Project Title	Transalloys Manganese Alloy Smelter Energy Efficiency Project
ERM CVS Reference	2004.V1
CDM Project Reference Number	1027
Client Name	EcoSecurities International Ltd.
Client Address	40 Dawson Street, Dublin 2, Ireland

CDM Verification and Certification Report

Version Control	Date
Version 01	16 June 2011 (draft report)
Version 02	30 January 2012 (final report)
Version 02.1	04 April 2012 (final report after incompleteness)

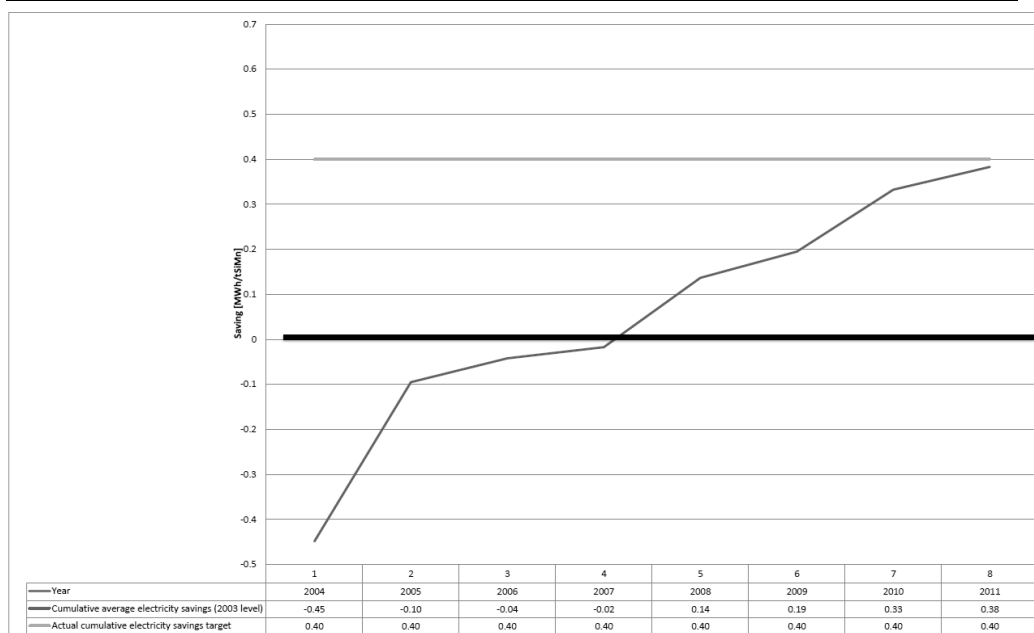
Clarification Request:	CL3: Please explain how the increased electricity savings observed during this monitoring period do not constitute a permanent change in the assumptions applied at the time of validation and registration of the project, particularly in relation to the values applied in the sensitivity analysis.
PP Response:	PP agrees that the electricity savings in this monitoring period ("M4", i.e. 01/03/2010 - 30/04/2011) are higher than the values applied in the sensitivity analysis, and indeed the registered PDD predicts this. There is however, no permanent change between the PDD and the actual project performance, such that a change to the PDD is not required. The essence of this illusion of higher performance is that the Verifying DOE is requesting a comparison between a <i>portion</i> of the crediting period ("M4") and the <i>whole</i> crediting period (i.e. sensitivity analysis) to date. To undertake a fair and representative comparison between M4's and the whole crediting period's (i.e. the sensitivity analysis') electricity savings, there needs to be an "apple with apple" comparison necessitating inclusion of past project

The result of the second approach to achieving an "apple with apple" comparison (as per Table 1's actual data) is that *actual electricity savings from the start of the crediting period through the end of M4, are 0.38 MWh/tSiMn, which are lower than the 0.4 MWh/tSiMn used in the sensitivity analysis of the registered PDD*. Therefore, the increased M4 electricity savings do not constitute a permanent change in the assumptions applied at the time of validation and registration of the project, particularly in relation to the values applied in the sensitivity analysis.

Graph 1: Erratic furnace performance

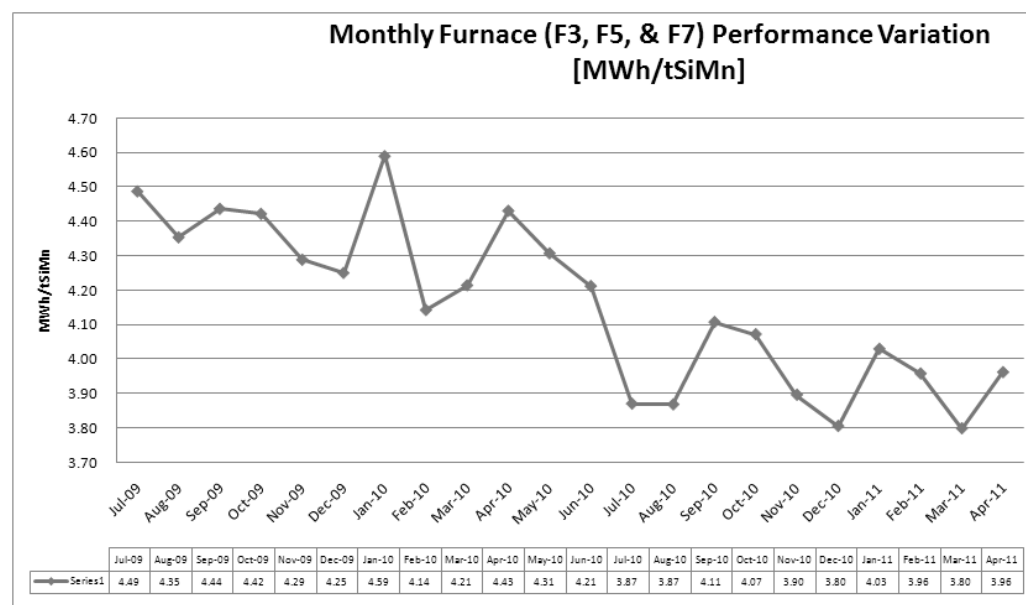
CAR1	
Date raised	09 June 2011
Comment:	During the review of reasons as to the difference in ERs achieved during the monitoring period versus that amount estimated in the PDD, the detail provided for reason 2b ("Higher electricity savings") was not adequate due to the fact that operational and management changes took place on site during the monitoring period and the detail of these management and operational changes, as well as their effect on the CDM project and CER achieved was not discussed.
Corrective Action Request:	CAR1: Relating to the difference in ERs achieved during the monitoring period versus that amount estimated in the PDD (and the noticeable reduction in MWh/ton SiMn produced for this monitoring period), please quantify the influence of the management and operational changes with subsequent electricity efficiency improvements, and the potential effect on CERs if not CDM related.

PP Response:	<p>No major modifications were undertaken in the furnaces aside from the Pitch Centre Diameter ("PCD") modification. There have been continuous management and operational changes, some of which <i>could</i> have been applied to the baseline scenario, but this does not change the fact that <i>once</i> a major change, (such as with the project PCD), has been effected, further fine-tuning is <i>necessary</i> to realise optimum furnace performance. Without such fine-tuning, it would be unrealistic and improbable to achieve the set target. The methodology is <i>clear</i> that the baseline should be fixed and based on real data, such that even if the same management and operational changes had been applied to the baseline scenario (without the PCD modification), it would be impossible to quantify the effect on furnace electricity consumption. Graph 1 (below) illustrates the high variation in furnace performance <i>without</i> undertaking any change (major or minor).</p> <p>The only apparent non-PCD reason for increased furnace performance relates to the reduction of slag usage in the furnaces (and the accompanying reduction in electricity consumption per product), <i>however</i> this improvement is a <i>direct bi-product of the PCD change</i>. Prior to PCD optimisation, there had been</p>

electrode depth issues which resulted in frequent electrode breaks and carbon build-up, and the need to add slag to the mix to facilitate the reaction. After the PCD was optimised, the project developer was able to fine tune electrode depths, reducing the dependence on slag (as an additive), resulting in energy savings, since more slag in the furnaces requires more electricity without yielding increased product.

The Monitoring Report for M4 has been amended to include further detail relating to the difference in CERs achieved during the monitoring period versus that amount estimated in the PDD.
